IC Corporation

SAFETY RECALL 05508

August 2005

Excessive suspension travel may cause the u-joint straps or strap bolts on either end of the driveshaft to fail as a result of the high working angle.

REPLACE LEFT AXLE STOP - Refer to Figure 1 below

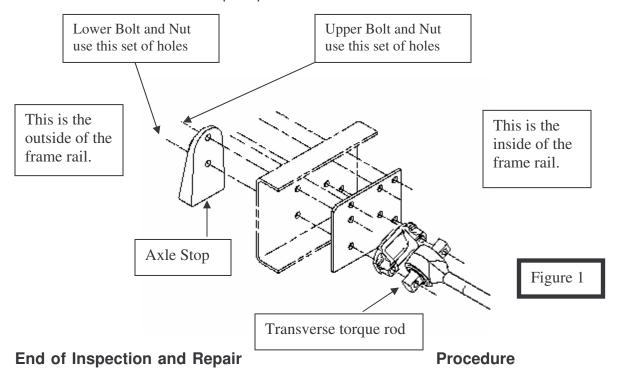
- 1. Remove Upper Nut and Upper Bolt that holds axle stop to frame rail.
- 2. Remove Lower Nut and Lower Bolt that holds axle stop to frame rail.
- 3. Replace axle stop with new one.
- 4. Replace the axle stop bolts and nuts with the **new** bolts and nuts that are included in the kit. Both bolts for the left side are the same length.
- 5. Torque the axle stop nuts to **between 196 and 239 LbF-Ft** (266-324 Nm).

- 1. Remove Upper Nut and Upper Bolt that holds axle stop to frame rail.
- 2. Remove Lower Nut and Lower Bolt that holds axle stop and transverse torque rod to frame rail.
- 3. Replace the axle stop bolts and nuts with the **new** bolts and nuts that are included in the kit. Both bolts for the right side are **NOT** the same length. Use the **longer** bolt to replace the Lower Bolt that also holds the transverse torque rod to the frame.
- 4. Torque the axle stop nuts to between 196 and 239 LbF-Ft (266-324 Nm).

The axle stops are held to the frame rail by 2 sets of bolts and nuts that pass through the frame rail. **Right side** is shown in Figure 1 below. The proper position of the bolts and nuts is to place the bolts into the holes from the inside, so that the nuts are on the outside of the frame rail. This correct position allows sufficient access to the nuts for the torque operation.
